NRG Knit Composite (Unit-1)

Enayetnagar, Volail, Fatullah
(23.619136N, 90.477915E)
29th January 2019

Observations

Retrofitting column layout plan

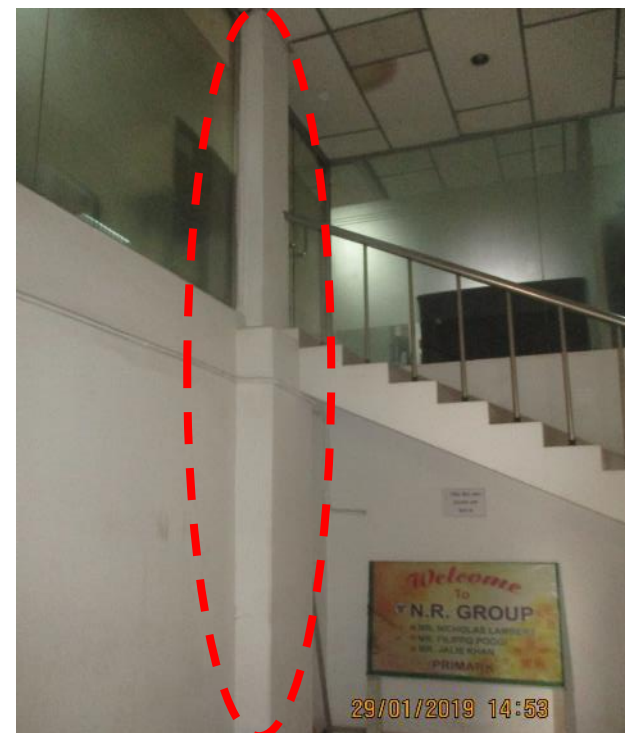
Columns were retrofitted up to bottom slab of mezzanine floor

In the provided retrofitted column layout, the marked columns were shown as retrofitted up to top slab of mezzanine floor. Whereas, the columns were found to be retrofitted till bottom slab of mezzanine floor. Factory is required to submit the design report to ACCORD for review and carry out remedial works coming from detail engineering assessment after reviewing by Accord.

Missing information in provided as-built drawing

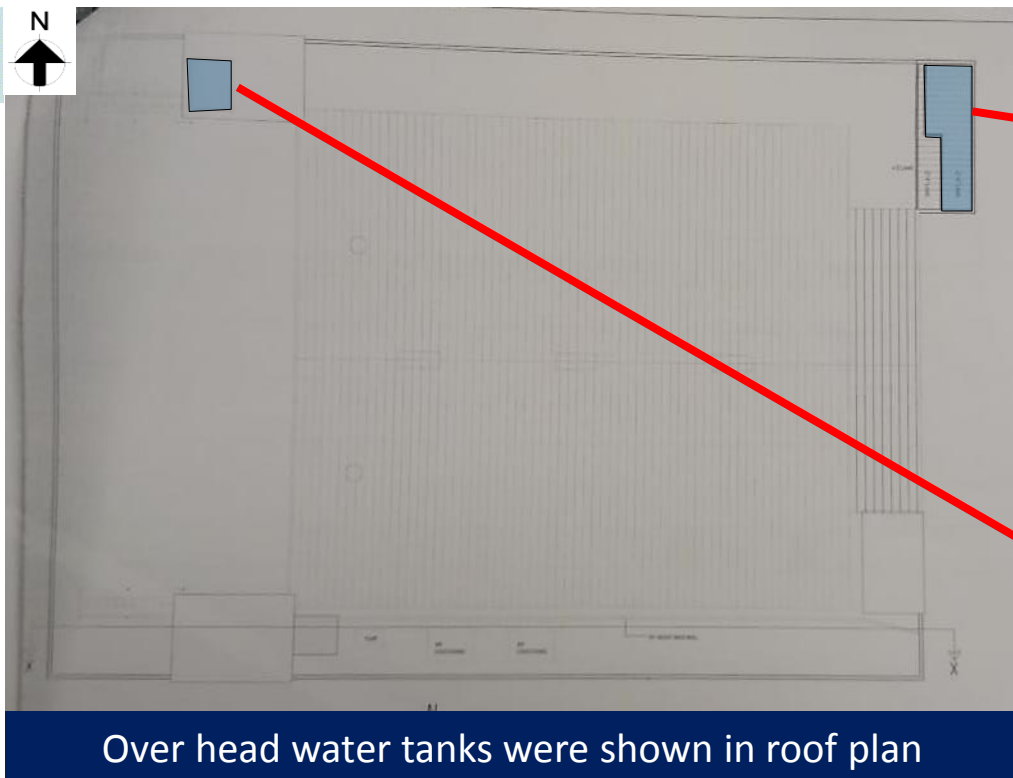
Over head water tanks were shown in roof plan

RCC water tank on existing roof

RCC water tank on existing stair case

In the provided drawing, no detail was found regarding the over head water tanks. Factory is required to produce the as built drawing addressing the detail of water tanks on roof.

Discrepancies between as-built drawings and on-site observation of roof top shed

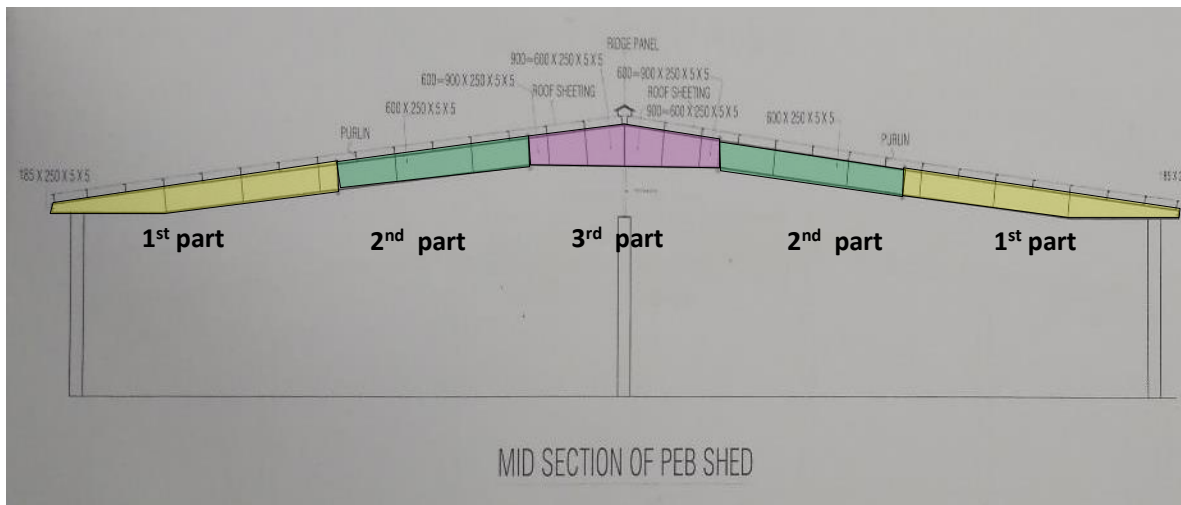
Dimension of rafter was found less than provided drawing

Different rafter width was found on site

Typical section of portal frame in as-built drawing

The rafter was divided into three part. The width of 1st part, 2nd part and 3rd part were measured 145mm, 160mm and 200mm respectively whereas the width was mentioned 250mm for three part in drawing. Factory is required to update the drawing and revise the analysis report.
